**WOKINGHAM
BOROUGH COUNCIL**

Full Planning Approval Consultation

Site Address: Hogwood Farm, Sheerlands Road, Arborfield, Wokingham, RG40 4QY

Proposal: Full application for the proposed erection of 48 residential dwellings with associated access, internal roads, parking, landscaping, drainage and cycle storage.

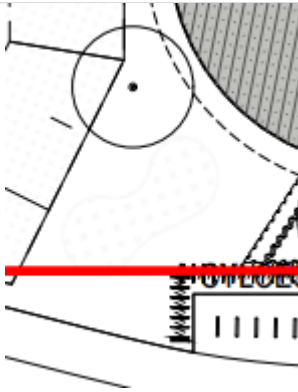
19. It is proposed that there are 2m pavements in front of the dwellings which is welcome.
20. However, highways would have expected to see crossing points with dropped kerbs and tactile paving. There appears to be no crossing point at the main access into the site.
21. With reference to the sports fields, highways would have expected to see a more direct pedestrian access from this development. A suggested location could be shown below, this would need looking at.
